Access Compliance Report

Public Rights-of-Way (Curb Ramps)

Intersection ID: 50516	Main Street: MICHAEL_CROSSING_DR	Cross Street: MCLEAN_RD	Location: NW
ADA ID: EE4CFE81A32D	Ramp Type: Combination2	Initial Pass/Fail: Fail	Overall Compliance: No
		Severity Score: 35

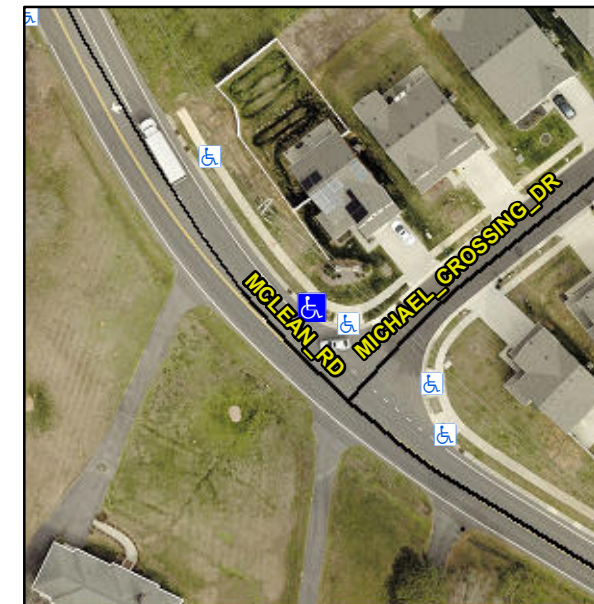
RT RP < 5%

Not Found, R304.5.1, R304.3.2, R304.5.3

Remove & Replace Entire Ramp.
